September 30, 2014

Third Modification to EPA's Final Determination for the South Terminal Project – Additional Dredging to Widen Channel and Associated Blasting for Rock Removal

**Third Modification to EPA's Final Determination for the South Terminal Project
New Bedford State Enhanced Remedy**

Figure 1

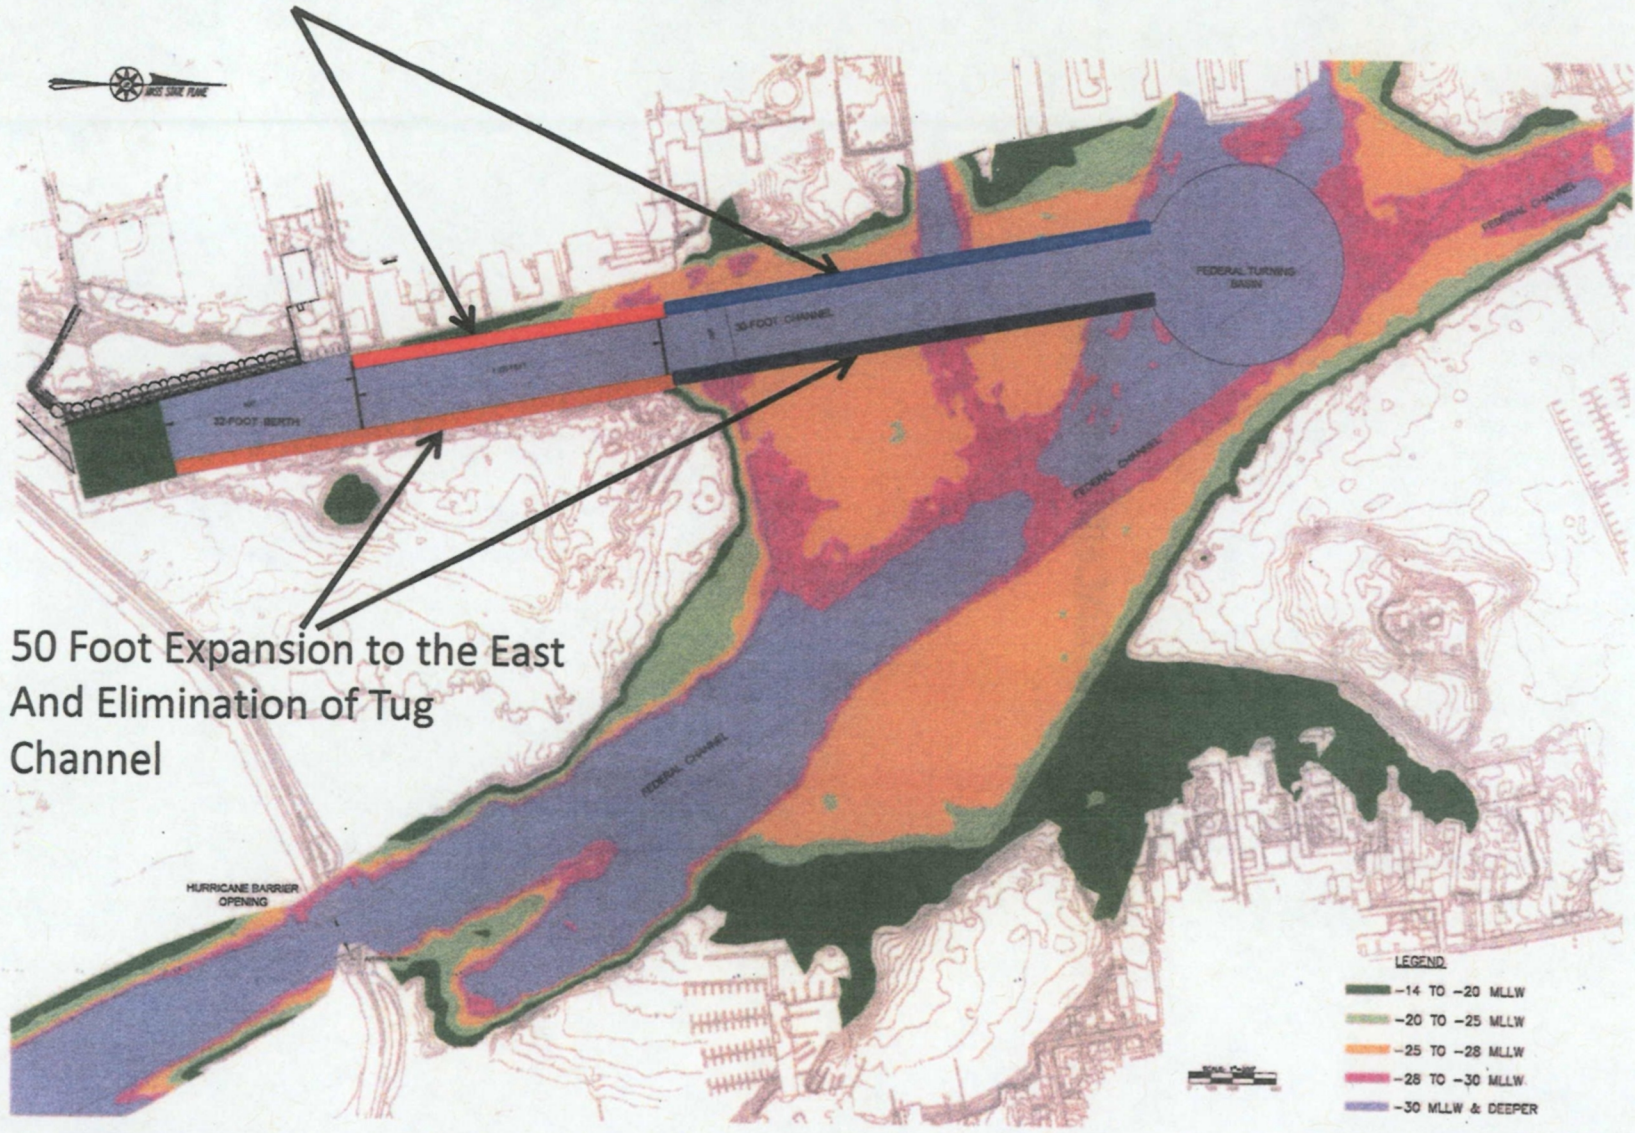
The dredging volume table originally attached as Table 1 to the Final Determination has been revised and is attached as Table 1 to this document. A map depicting the reconfiguration of the navigational channel and tug channel to a 300 foot wide channel is attached as Figure 1 to this document. A map of the subtidal blasting areas is attached as Figure 2. A map of the additional winter flounder mitigation area is attached as Figure 3.

25 Foot Expansion to the West

50 Foot Expansion to the East
And Elimination of Tug
Channel

Figure 2

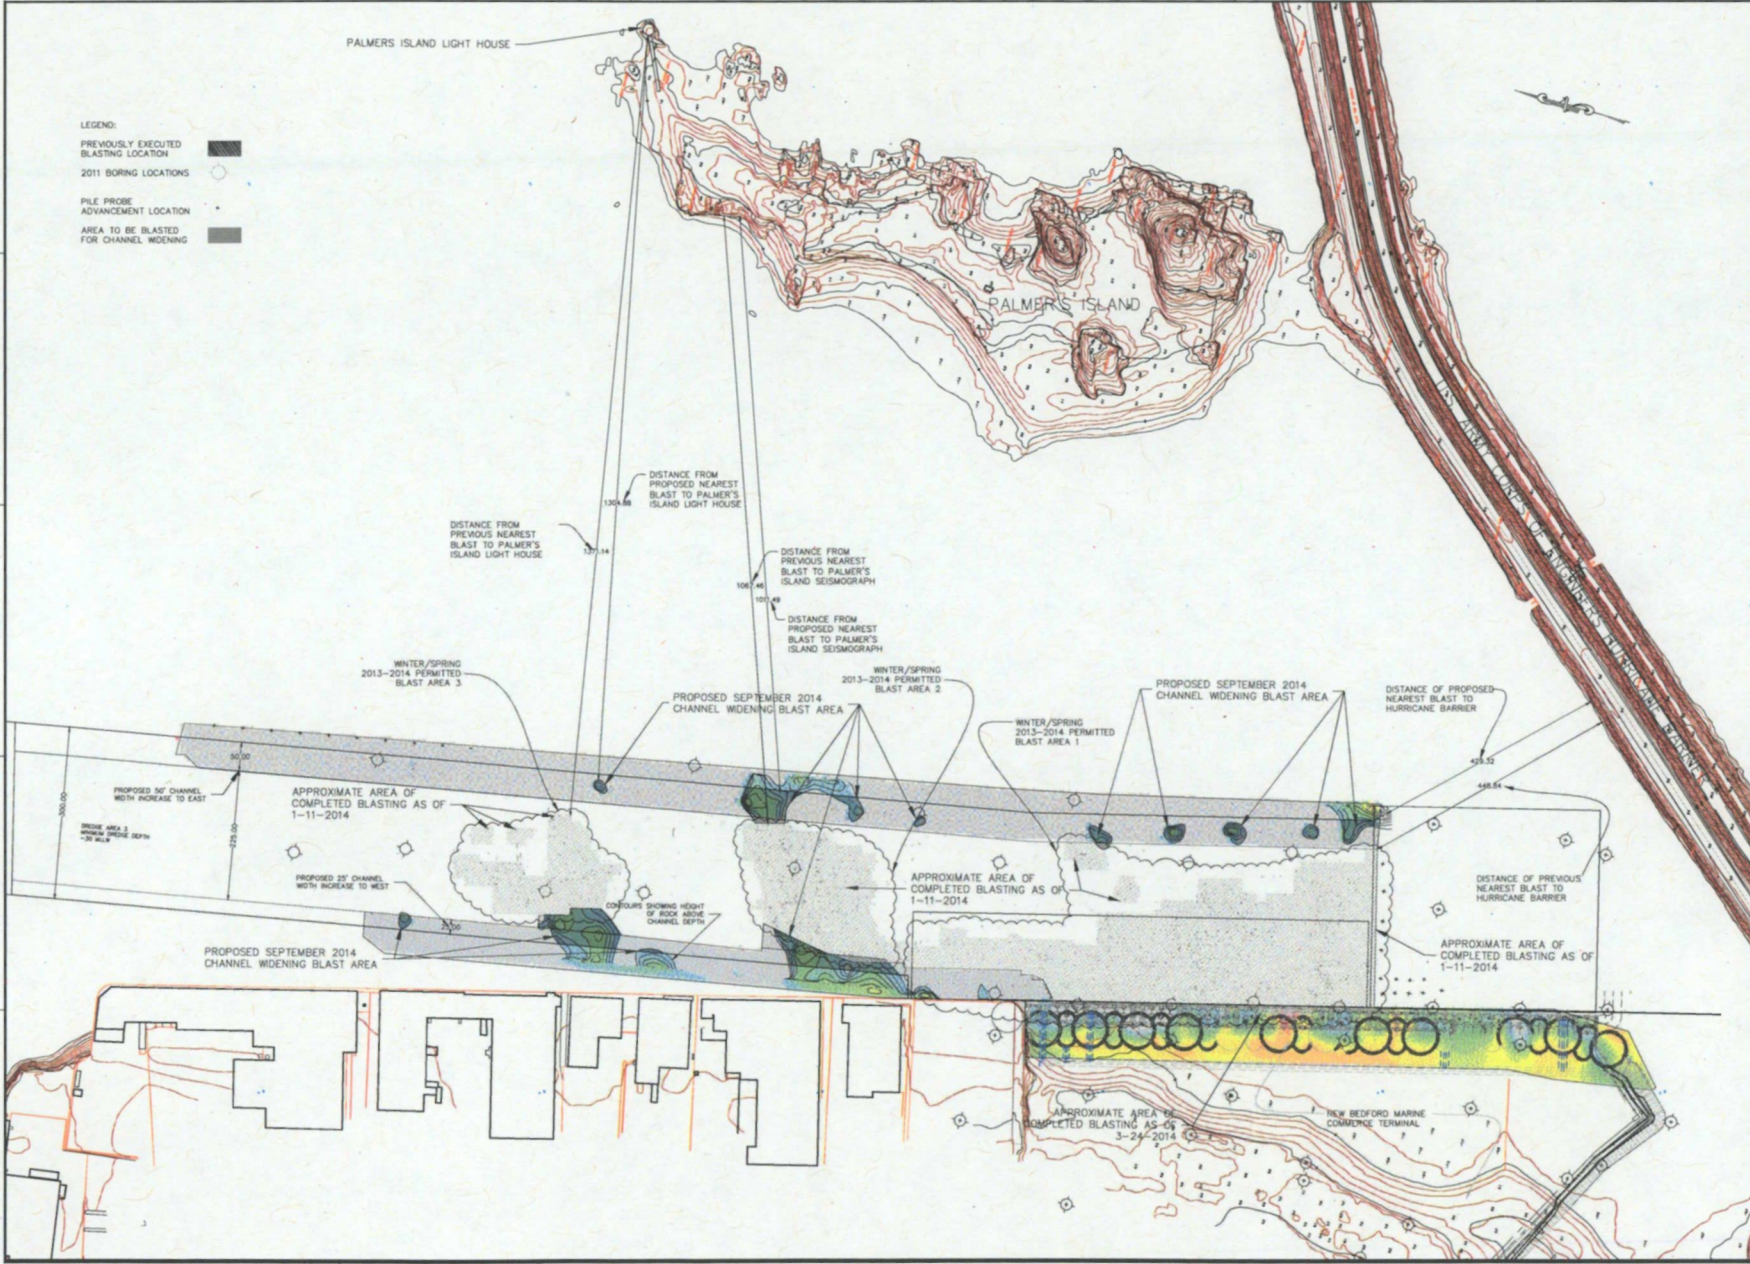
- a. Condition No. 1: A final blasting plan must be submitted to and approved by EPA before blasting commences;
 - b. Condition No. 2: Blasting shall only be conducted in the locations depicted on Attachment B of the Commonwealth's August 14, 2014 letter to EPA (See Figure 2 of this document); the remainder of this condition is not applicable to the current blasting request;

Figure 3

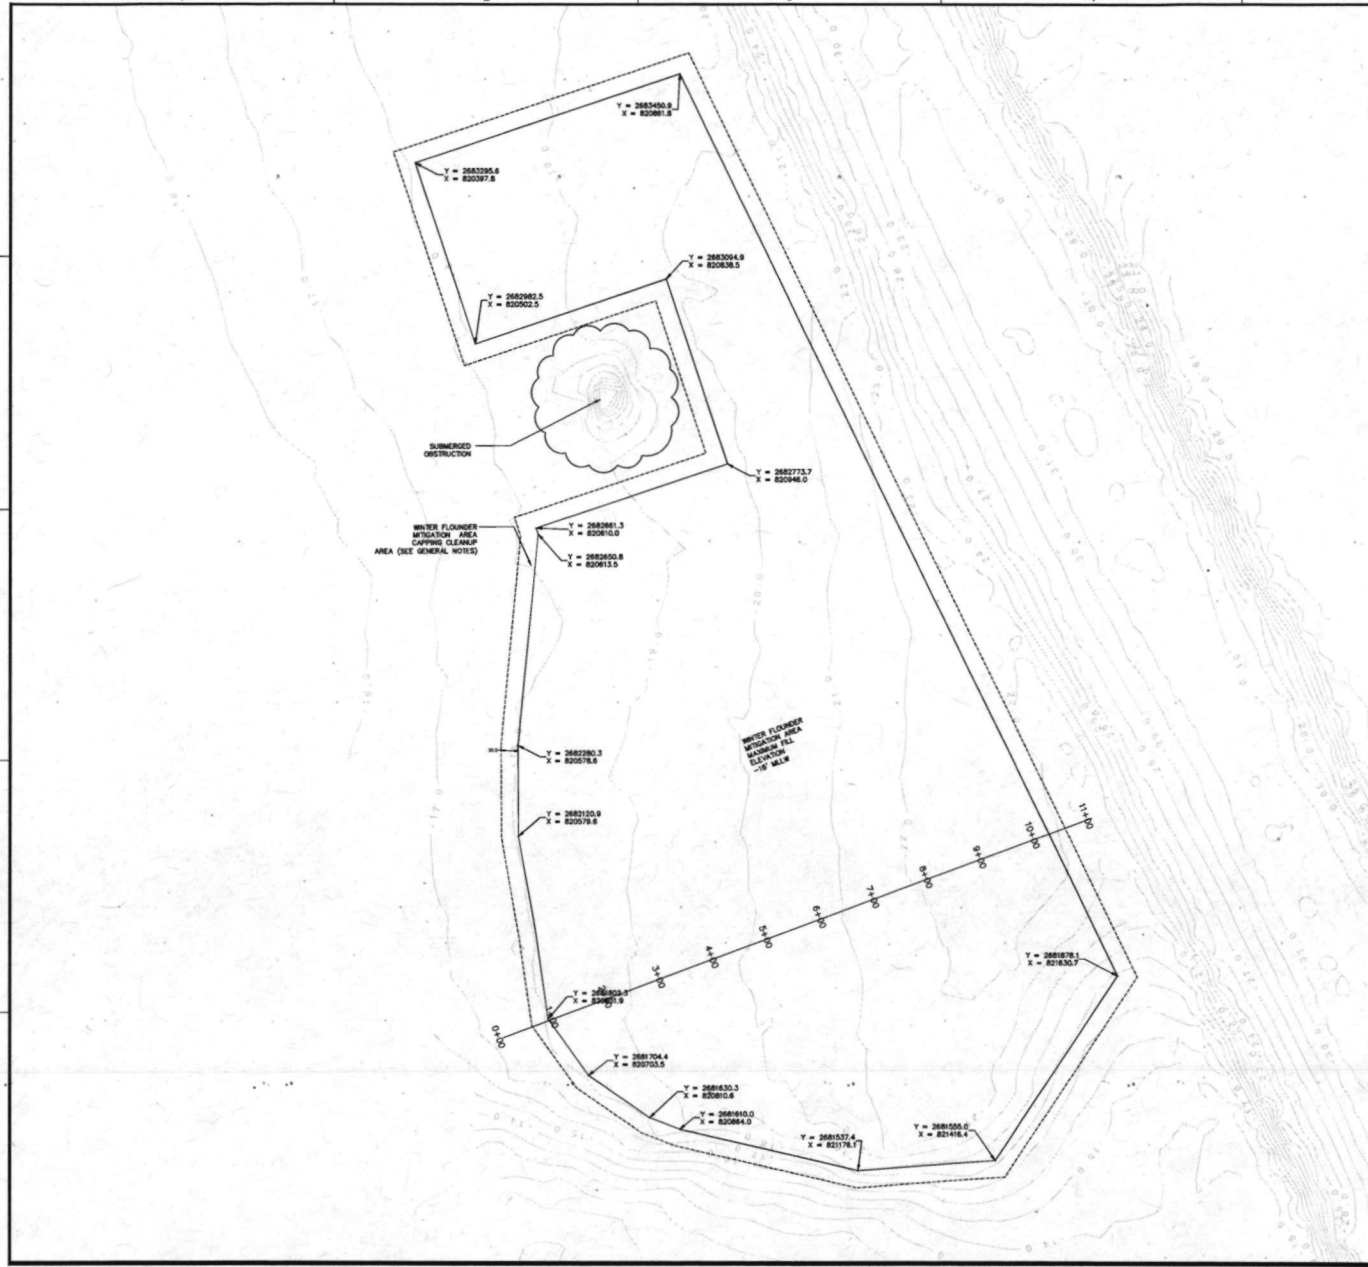
- Creates 4.6 additional acres of winter flounder habitat at the winter flounder mitigation area;
- Clarifies upland remediation at the Radio Tower parcel to include offsite disposal of material containing PCB-concentrations greater than or equal to (" \geq ") 50 ppm, capping and a change from ancillary to heavy load use; and

Figure 5

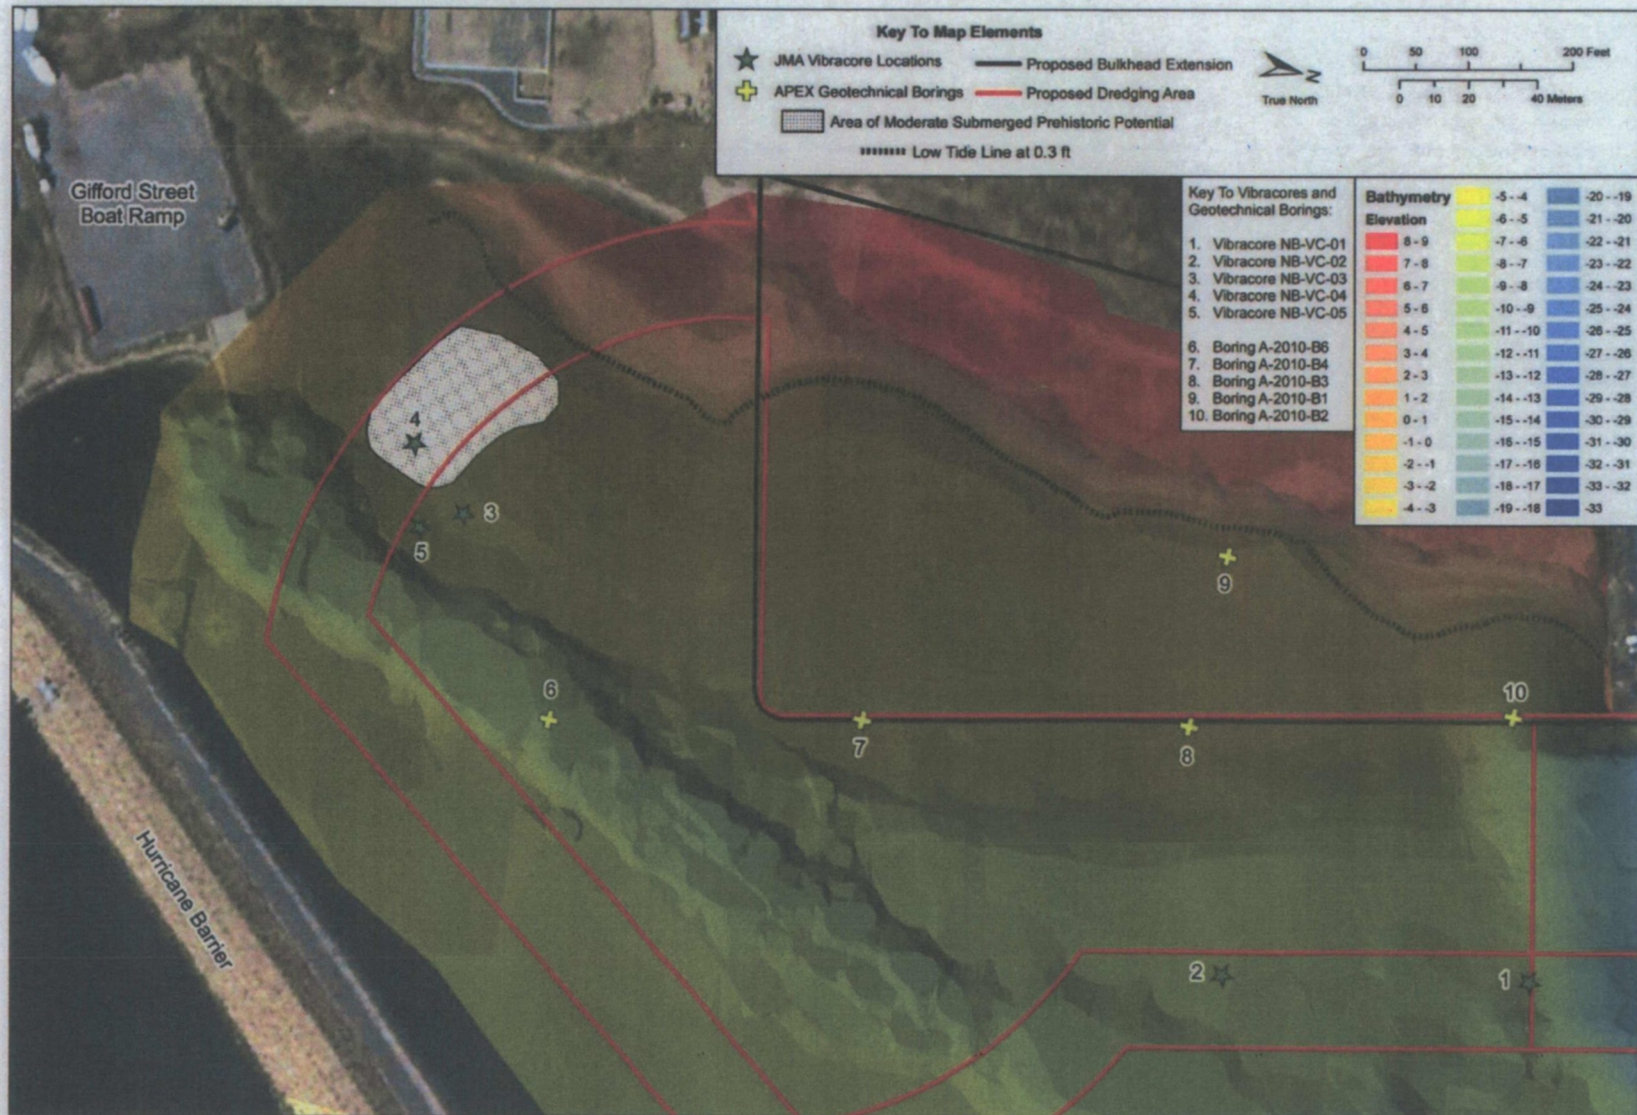
EPA has reviewed the archeological investigations in relation to the proposed additional dredging and the previously identified paleosols area. (See Figure 4 for map of areas of archeological survey.) The paleosols are located between the former Gifford Street boat ramp and the southern edge of the newly constructed terminal facility. (See Figure 5 for a mapped location of the paleosols area.) The expanded dredge area, although expanding laterally both east and west of the already authorized navigational channel, does not extend any further south than previously authorized dredging areas. The southern end of the 25 foot western lateral expansion stops north of the existing Shuster property; the southern end of the eastern lateral expansion stops approximately halfway along the edge of the newly constructed terminal. Neither expansion area is closer to the paleosol area than previously authorized dredging. See Figure 1.
